APPLICATION NO.	FILING DATE	FIRST NAMED INVENTOR	ATTORNEY DOCKET NO.	CONFIRMATION NO.	
10/038,264	01/03/2002	Seungbae Park	EN999048D	8328	
7.	590 10/09/2002				
David L. Banner Press Building - Suite 902 19 Chenango Street			EXAMINER		
			GARCIA, ERNESTO		
Binghamton, NY 13901			ART UNIT	PAPER NUMBER	
			3679		
			DATE MAILED: 10/09/2002

DETAILED ACTION

Attachment: one marked-up attachment of Burns et al., 5,118,299.

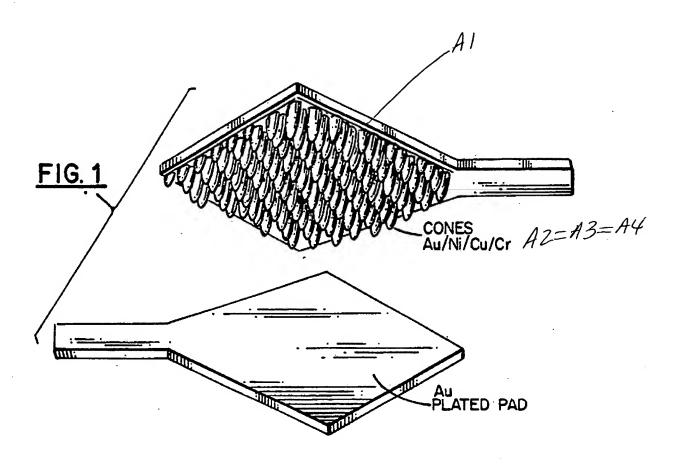
Claims 1 and 3-5 are rejected under 35 U.S.C. 102(b) as being anticipated by Burns et al., 5,118,299 (see marked-up attachment).

Regarding claim 1, the solder joint configuration comprising a pad A1 having an irregular boundary layer A2.

Regarding claim 3, the solder joint configuration comprising a pad A1 having an interdigitated boundary layer A3.

Regarding claim 4, the solder joint configuration comprising a pad A1 having a curved boundary layer A4.

Regarding claim 5, the curved boundary layer **A4** further comprises a substantially continuous structure.
